SUSTAINABLE DEVELOPMENT – URBAN DESIGN & PLANNING PLANNING & ZONING BOARD (PZB) RIGHT-OF-WAY VACATION APPLICATION

RE: Right-of-Way Vacation Application
West Village

Based on your DRC Review comments dated March 26, 2019 Keith and Associates (K&A) offers the following responses to your comments/questions:

ALT/NSPS LAND TITLE SURVEY

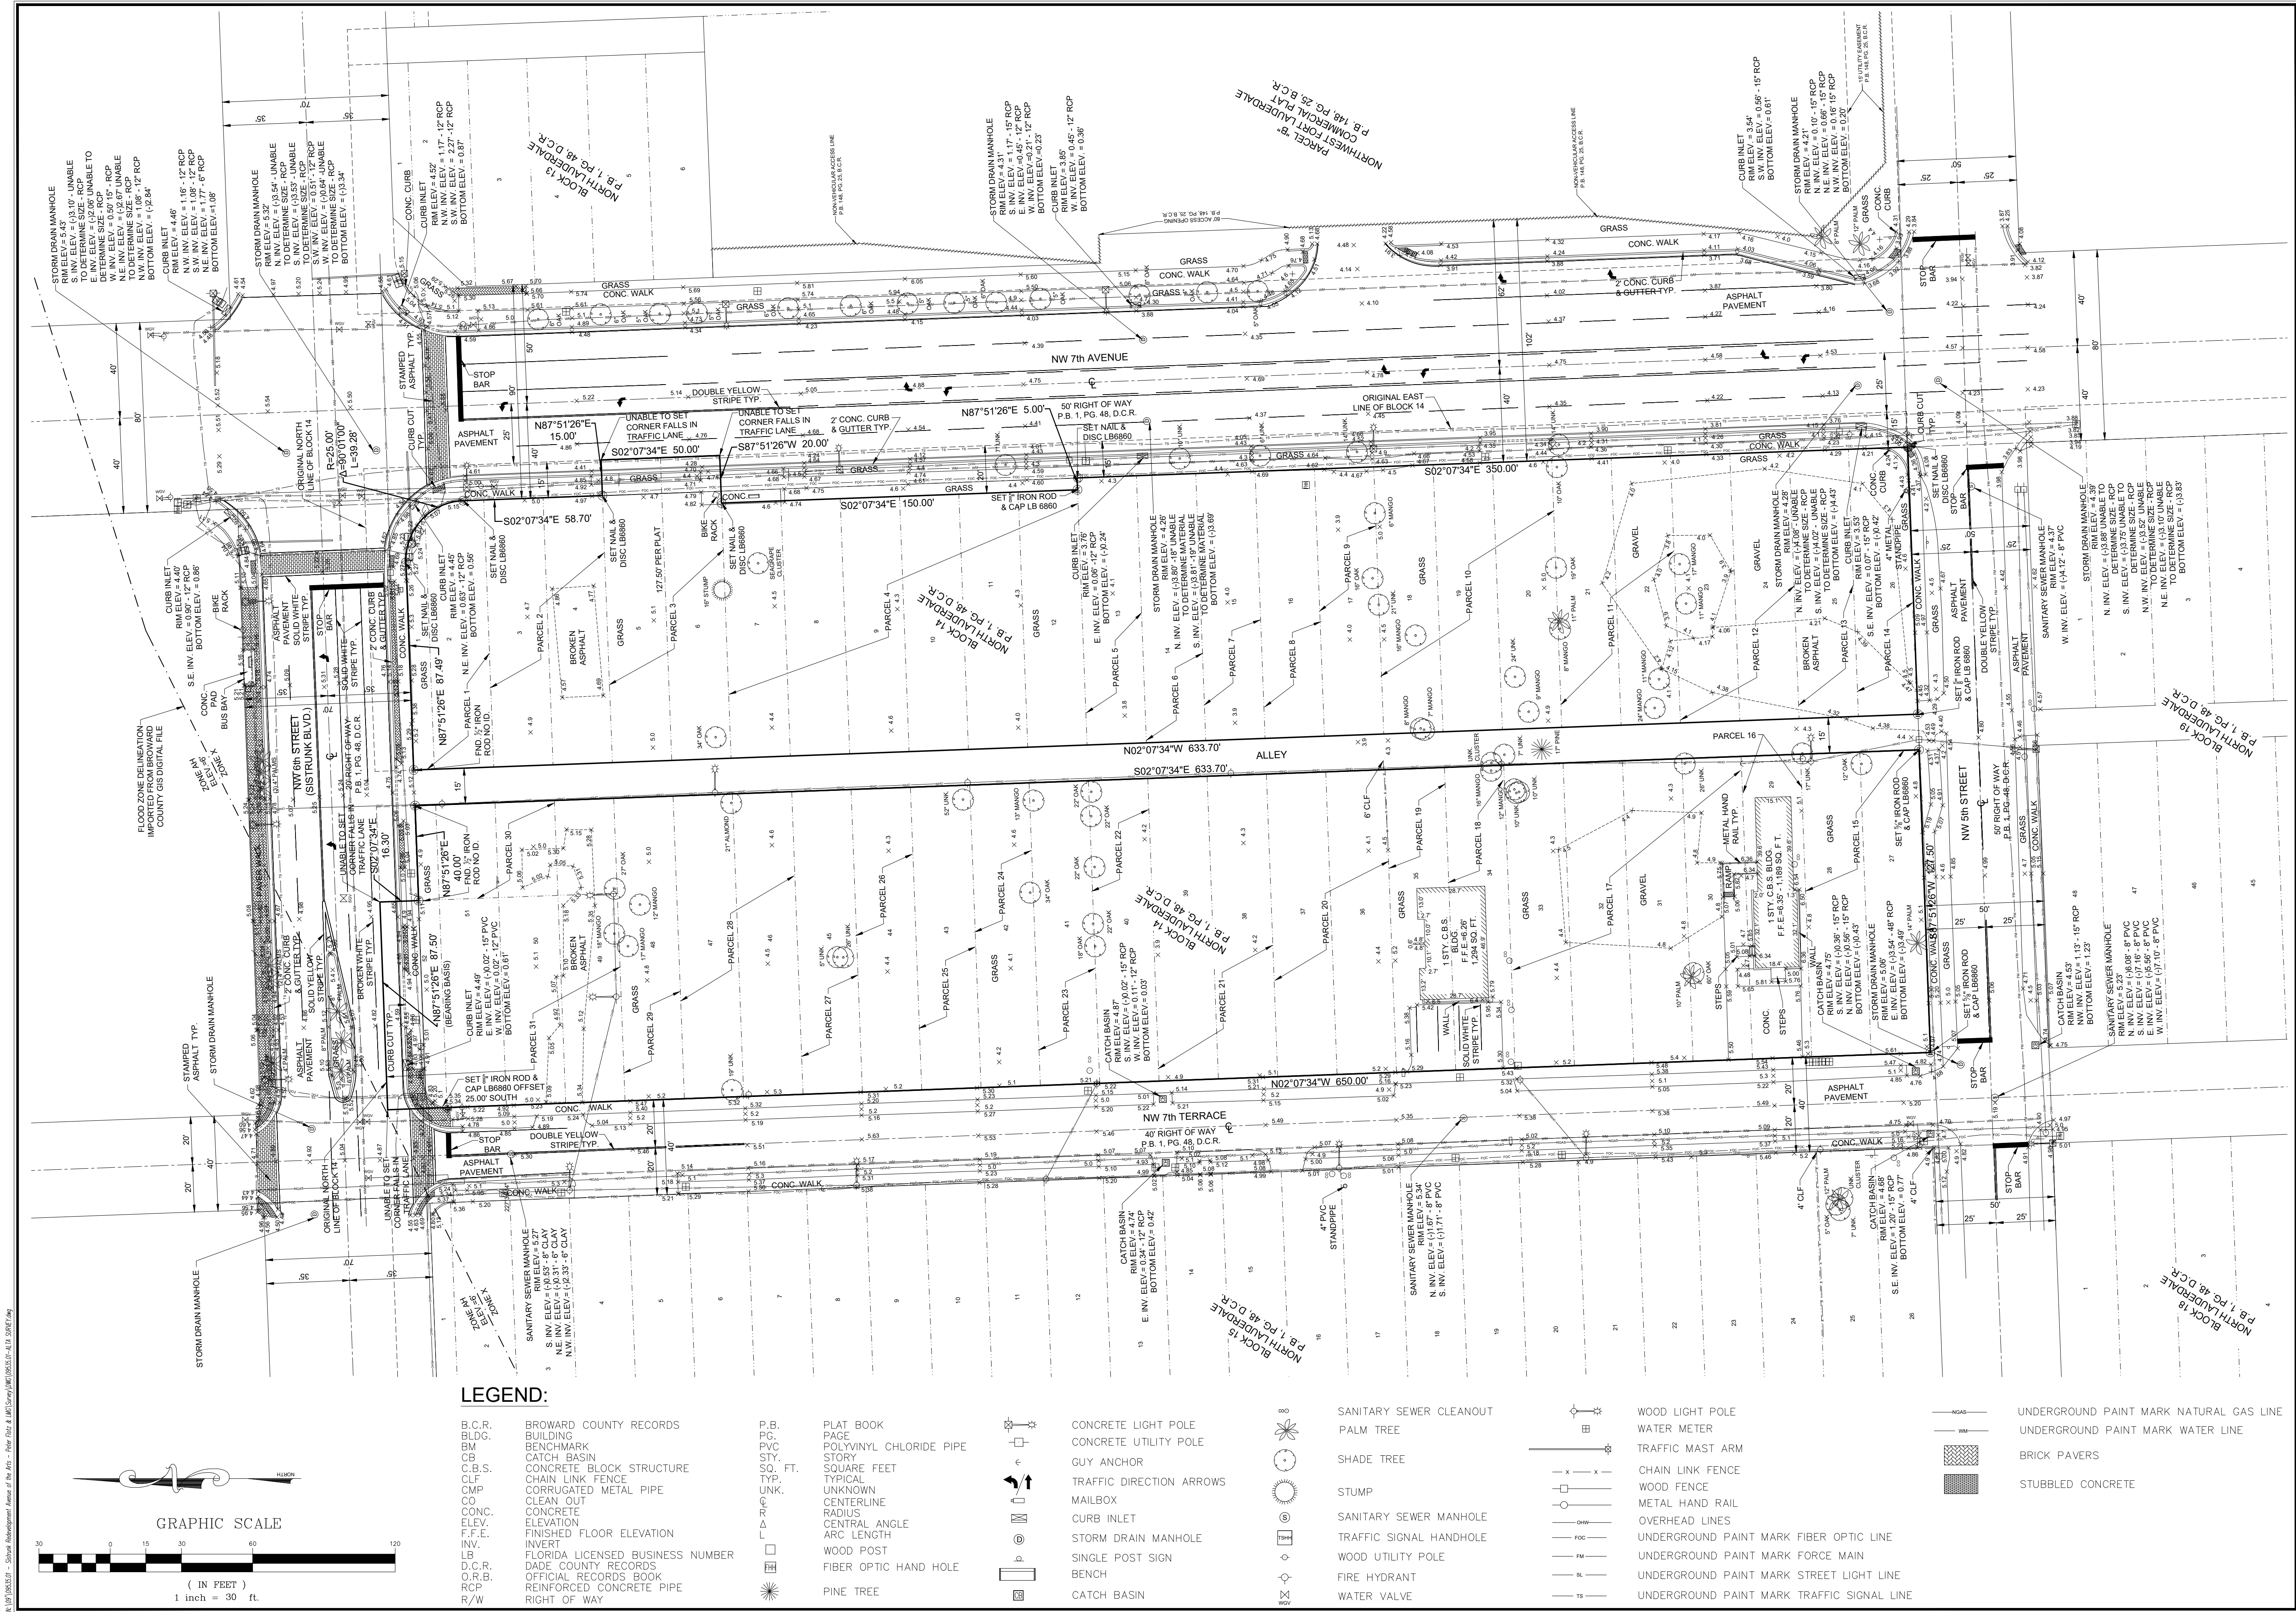
2. Provide a signed and sealed boundary and topographic survey showing all above ground improvements, utilities, rights of way dimensions and all easements. This survey shall be based on a Standard Title Commitment issued by a title insurer licensed to do business in Florida or an Opinion of Title issued by an attorney admitted to the Florida Bar.

RESPONSE: See attached ALTA/NSPS LAND TITLE SURVEY.
